Technical Comments

Comment on "Evolution of the Laminar Wake behind a Flat Plate and Its Upstream Influence"

Reply by Author to A. F. Messiter and K. Stewartson

Fig. 1 Relative slopes of the (effective) slender body.

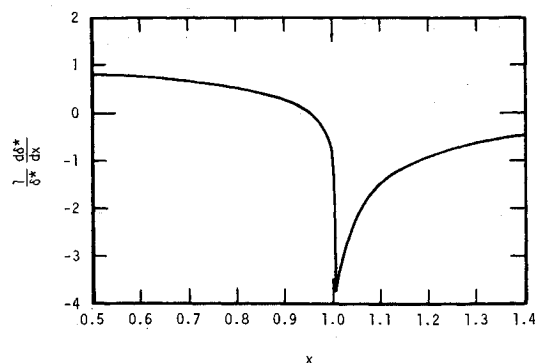
Second, it is stated in Ref. 1 that the use of linearized airfoil theory is not justified because of the large slopes of the (effective) slender body. It is certainly true that the slopes are large compared with the streamline slopes predicted by ordinary boundary-layer theory, but the slopes do remain small compared to 1. As explained in Refs. 2 and 3, $u = 1 + O(R^{-1/4})$, $v = O(R^{-1/4})$, $\partial u/\partial x = O(R^{-1/8})$, etc. In fact, Eq. (7) of Ref. 1 essentially incorporates the notion of linearization because the term $v \partial u/\partial y$ is omitted. Also, as Fig. 6 of Ref. 1 makes clear, $|c_p| \sim 0.01$ and therefore $c_p = -2(u-1)$ with error ~ 0.0001 .

able; however, as illustrated in Fig. 1 the normalized slopes of the (effective) slender body are somewhat larger than $O(1)$ behind the trailing edge. Thus, the authors decided, within the framework of

an "exact" treatment of the over-all problem, to forego linearized airfoil theory.
